Re: Petition No. 1424 - Southington Solar One, LLC petition for a declaratory ruling, pursuant to Connecticut General Statutes §4-176 and §16-50k, for the proposed construction, maintenance and operation of a 4.725-megawatt AC solar photovoltaic electric generating facility located at 1012 East Street, Southington, Connecticut, and associated electrical interconnection

**SOUTHINGTON SOLAR ONE, LLC'S RESPONSES TO THE CONNECTICUT
SITING COUNCIL'S APRIL 1, 2021 (SET 4) INTERROGATORIES**

**Community Garden Area:
Proposed Conditions Map**
Proposed Solar Facility - Southington Solar One
1012 East Street
Southington, Connecticut

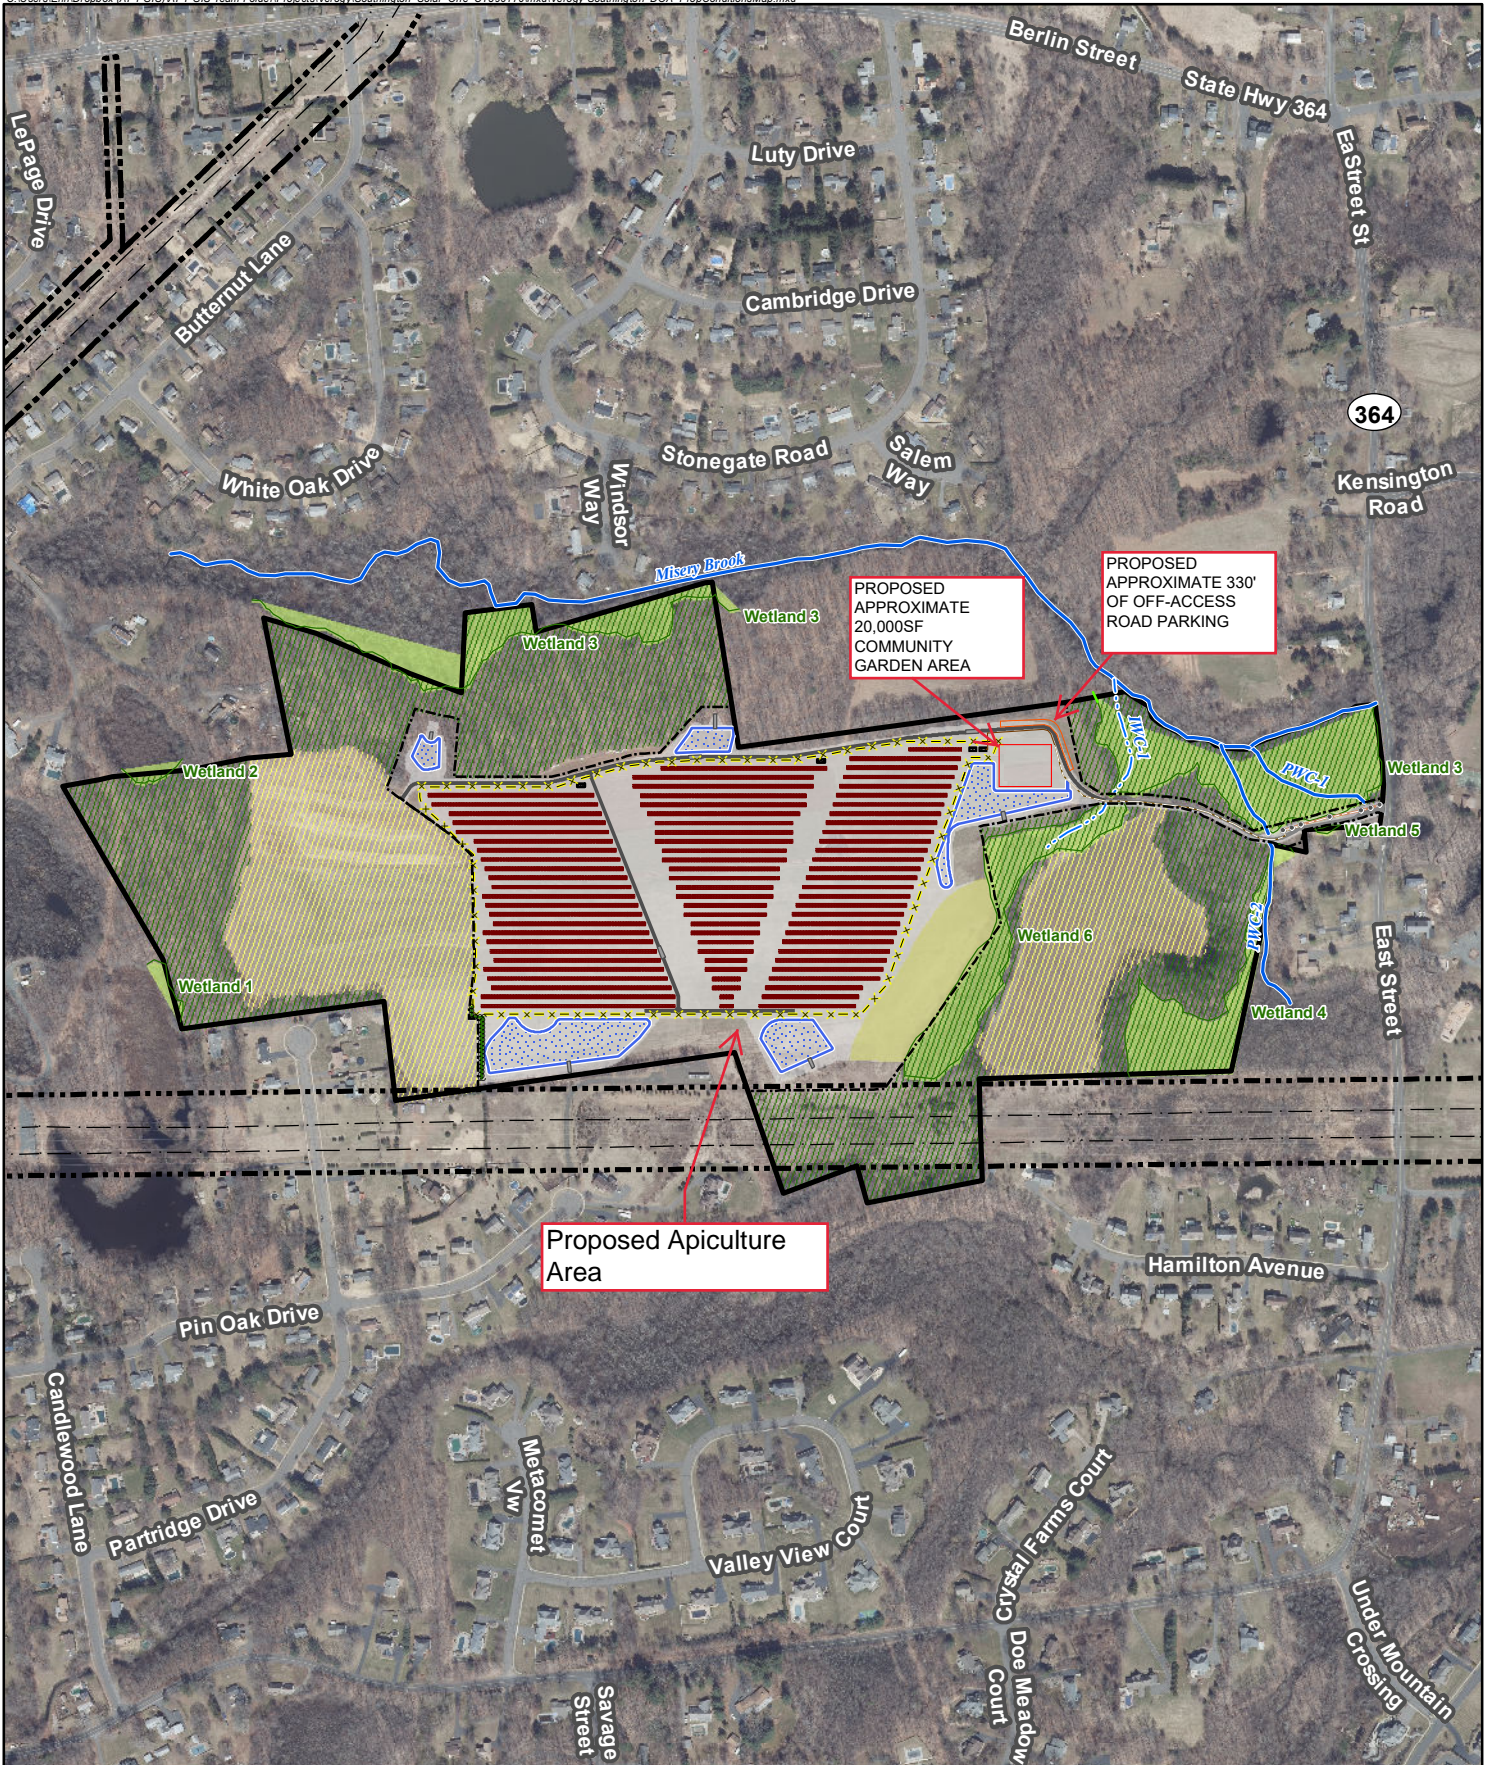
b. Where would the apiculture area be located?

c. How would the hives be protected from nuisance wildlife, such as bears?

As proposed, the apiculture area would be sited outside of the south-central fenced limits of the Project. Please refer to the attached *Community Garden Area: Proposed Conditions Map*, included herein as Exhibit A, for the planned location of the apiculture area.

The hives will be located outside of the south-central fenced limits of the array and protected from nuisance wildlife using ElectroNet fencing, which is said to be an effective deterrent against bears and other potential predators of the hives.
